**A. SUBJECT:**

Replacement of water thermostat.

**B. AFFECTED AIRPLANES:**

**C. REASON:**

Figure 2

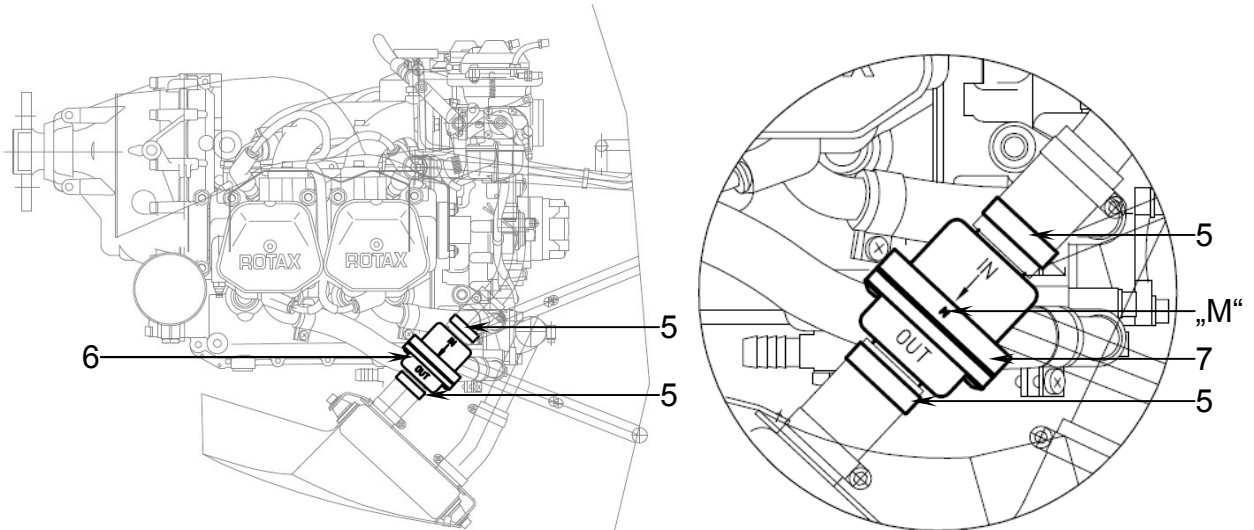
### 3. Water thermostat replacement (Figure 2).

3.1. Release the clamps (5) and remove the original water thermostat type F1102 (6).

3.2. Install new water thermostat DYN-170-141 (7) marked by "M" at the same position.  
 Check the correct IN/OUT direction of installed thermostat.

3.3. Finalize the clamps (5).

Figure 4

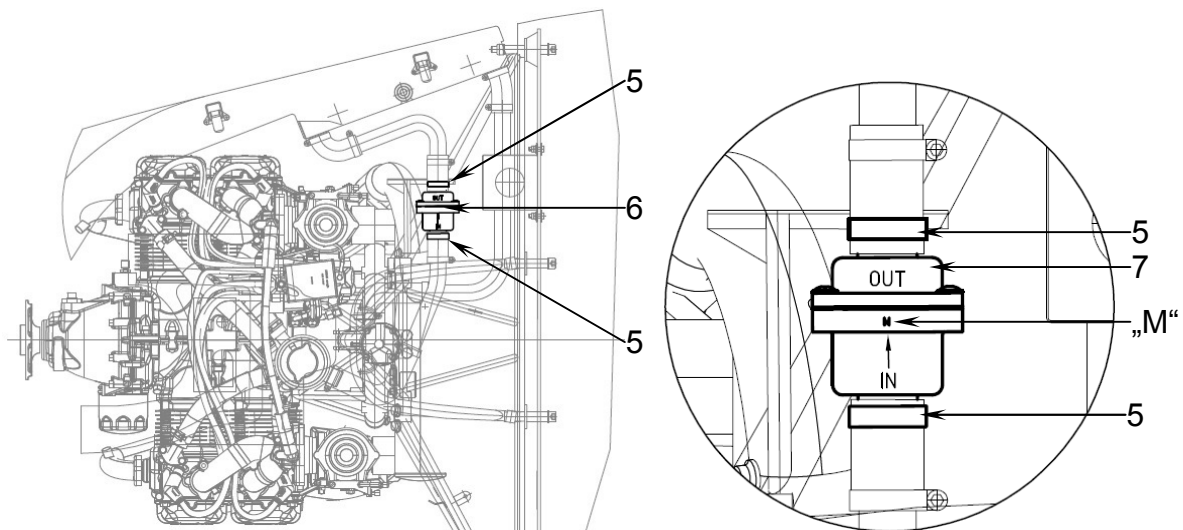
3. Water thermostat replacement (Figure 4).
  - 3.1. Release the clamps (5) and remove the original water thermostat type F1102 (6).
  - 3.2. Install new water thermostat DYN-170-141 (7) marked by "M" at the same position.  
 Check the correct IN/OUT direction of installed thermostat.
  - 3.3. Finalize the clamps (5).
